Access Compliance Report

Public Rights-of-Way

(Curb Ramps)

Intersection ID: 42914	Main Street: CROSSWALK_DR	Cross Street: FOREST_CROSS_DR	Location: E
ADA ID: 4E8AB26F2728	Ramp Type: PerpDiag	Initial Pass/Fail: Fail	Overall Compliance: No
Severity Score: 8.75			
Codes/Mitigation Info/Possible Solution		Field Measurements/Component Compliance

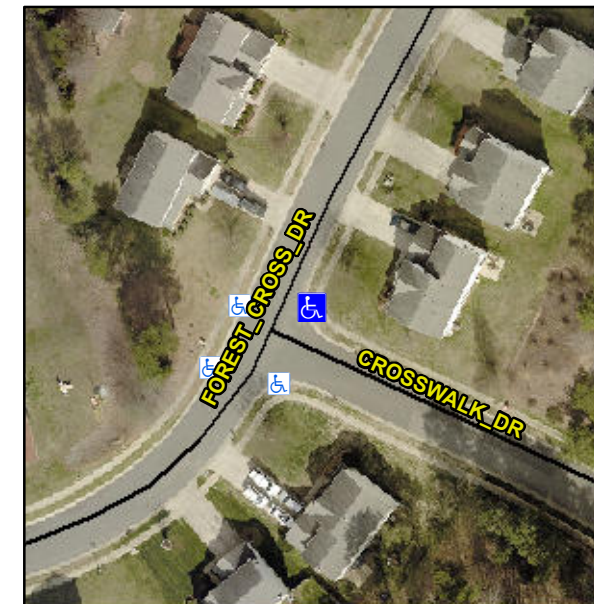
Compliance	Description	Data	Compliance	Description	Data
N/A	Ramp Length (in)	50.0	Yes	Ramp Slope (%)	6.1
No	Ramp Width (in)	44.5	Yes	Ramp XSlope (%)	0.8
N/A	Flare Type LT	N/A	N/A	Flare Type RT	N/A
N/A	Flare Slope LT (%)	N/A	N/A	Flare Slope RT (%)	N/A
N/A	Flare Traversable LT?	N/A	N/A	Flare Traversable RT?	N/A
N/A	Landing Length (in)	N/A	N/A	DWS Provided?	N/A
N/A	Landing Width (in)	N/A	N/A	DWS Contrast?	N/A
N/A	Landing Slope (%)	N/A	N/A	DWS Length (in)	N/A
N/A	Landing X Slope (%)	N/A	N/A	DWS Full Width?	N/A
N/A	Landing Curb? (Y/N)	N/A	N/A	DWS Offset (in)	N/A
N/A	Shared Landing?	N/A			
N/A	Gutter Ponding?	N/A	N/A	Gutter Slope (%)	N/A
N/A	Gutter Lip Ht (in)	N/A	N/A	Gutter X Slope (%)	N/A
N/A	Painted X Walk1?	No	N/A	Painted X Walk2?	No
	X Walk 1 Direction	To NW		X Walk 2 Direction	To SW
N/A	X Walk 1 Width (in)	N/A	N/A	X Walk 2 Width (in)	N/A
	X Walk 1 Slope (%)	2.0		X Walk 2 Slope (%)	0.2
	X Walk 1 X Slope (%)	0.3		X Walk 2 X Slope (%)	0.4

N/A	Ramp inside XWalk1?	N/A	N/A	Ramp inside XWalk2?	N/A
	Road Slope (%)	0.0	N/A	Clear Space?	N/A
	Road X Slope (%)	0.9	N/A	Clear Space to XWalk (in)	N/A
N/A	Any Obstructions?	N/A	N/A	Storm Grate/Utility Hazard?	N/A
	Obstruction Type			Storm Grate/Utility Type	
		N/A			N/A
			Yes	Surface Condition? (G/P)	Good

Remove & Replace Curb Ramp With Two New Directional Ramps or Equivalent.

Not Found, R304.5.1
